Agenda Item: 650-1097

Title: API-620 Outlet Allowance

Purpose: To allow the use of studded outlets as shown in API-620 figure.

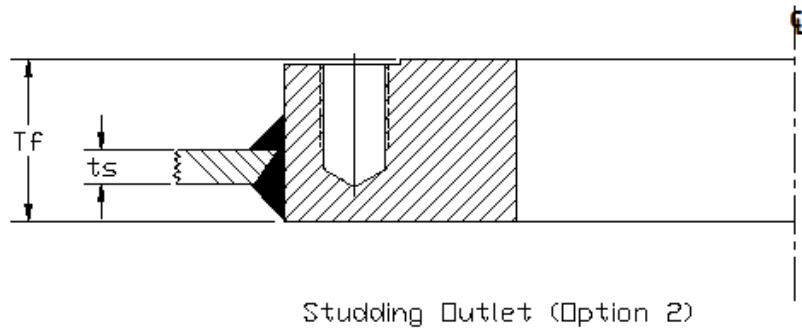
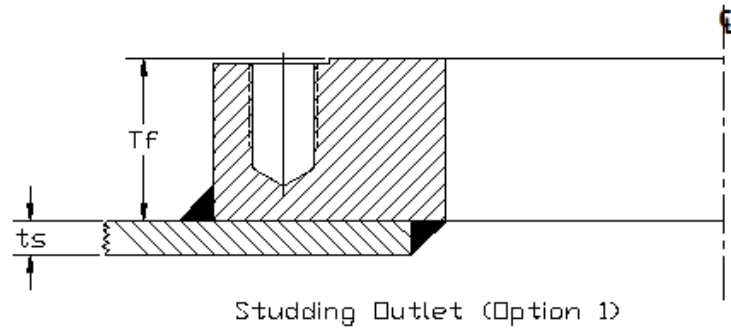
5.7.2.1 Openings in tank shells larger than required to accommodate a NPS 2 flanged or threaded nozzle shall be reinforced. **All studding outlets inserted into the shell or studding outlets placed on the outside of the shell and are larger than NPS 2 shall be reinforced and their required area of reinforcing, available area of reinforcing, and weld strengths shall be calculated in accordance with 5.7.2.3 thru 5.7.2.8.** The minimum cross-sectional area of the required reinforcement shall not be less than the product of the vertical diameter of the hole cut in the shell and the nominal plate thickness, but when calculations are made for the maximum required thickness considering all design and hydrostatic test load conditions, the required thickness may be used in lieu of the nominal plat thickness. **For studding outlets, the area of the bolts bolt holes within the limits of reinforcement shall be added to the minimum cross-sectional are-of-the area required reinforcement.** The cross-sectional area of the reinforcement shall be measured vertically, coincident with the diameter of the opening.

through the shell are those that do not require reinforcement, **studding outlets of any size placed on the outside of the shell**, and those that utilize a thickened insert plate as shown in Figure 5.7b and Figure 5.8. However, any openings listed in Table 3 of the Data Sheet that are marked “yes” under “Full Penetration on Openings” shall utilize welds that fully penetrate the shell and the reinforcement, if used.

Studding Outlet (Option 1)

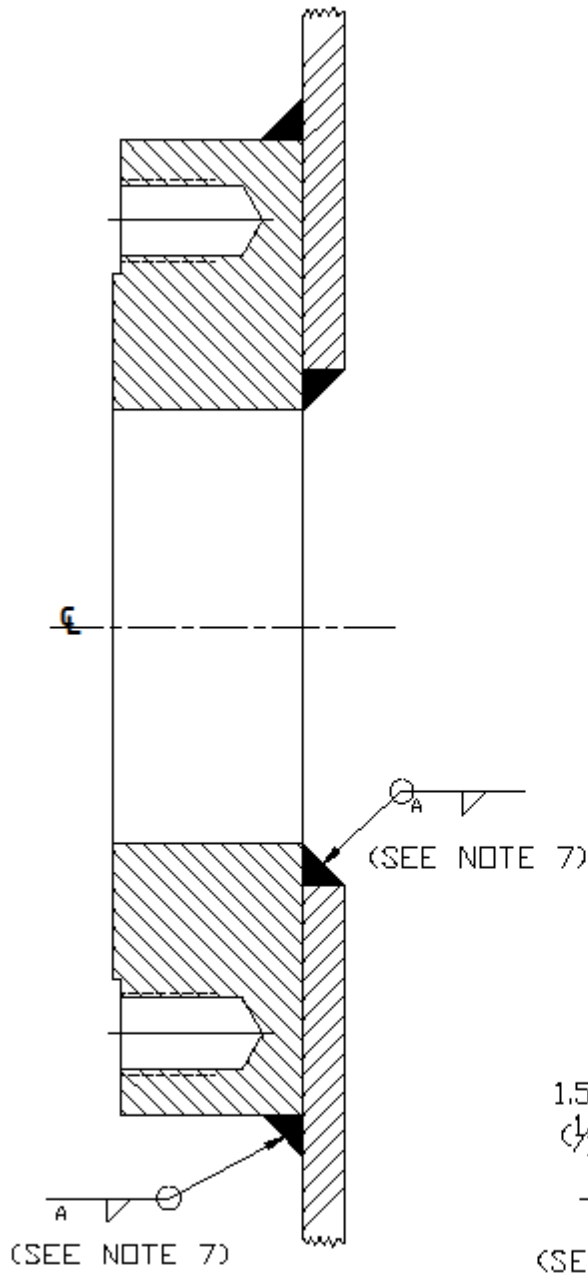
Add sketch to Figure 4.3

Add sketch to Figure 5.8
